Swimming Pool Technical Advisory Committee (TAC) – Comments

9th Edition (2026) Florida Building Code, Building

SW – Ch. 4 - B Comment #1

SW – Ch. 4 - B Comment #2

Figure 40.3
Strip Style Skimmer

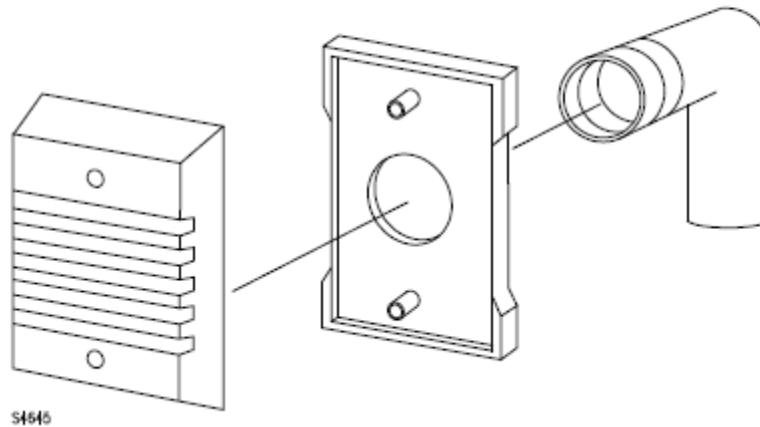
40.10.8 Skimmers represented by the general descriptions in (a) – (c) and conforming to the overall general shapes and designs (or the equivalent) illustrated in Figure 40.1 – Figure 40.3 are not required to comply with the requirements in 40.10.3 – 40.10.8.

c) Strip Style Skimmer – A vertically-mounted, rectangular-shaped skimmer installed in the side wall of the spa shell. Two-piece construction (faceplate and threaded back plate). ...

This **exception** would relax the APSP standard #16 for hair and body entrapment.
